Access Compliance Report

Public Rights-of-Way

(Curb Ramps)

Intersection ID: 5832	Main Street: N_TRYON_ST	Cross Street: KEN_HOFFMAN_DR	Location: NE
ADA ID: C22B549D3EAD	Ramp Type: Perp	Initial Pass/Fail: Pass	Overall Compliance: No
Severity Score: 20			
Codes/Mitigation Info/Possible Solution		Field Measurements/Component Compliance

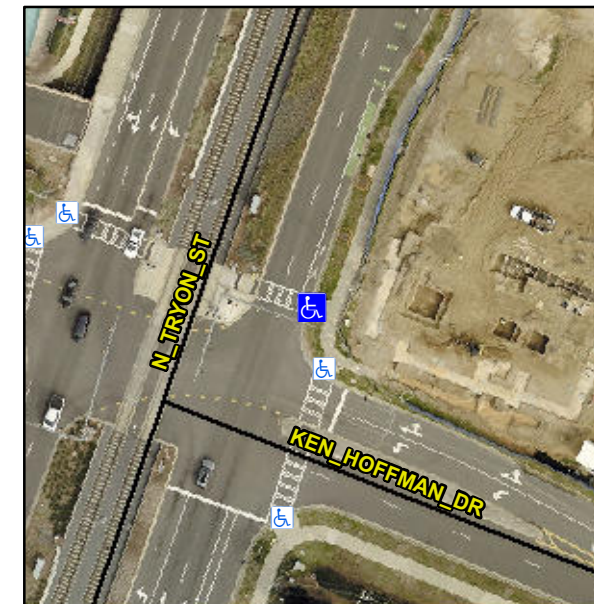
R302.7.2, R304.5.4

Remove & Replace Gutter.
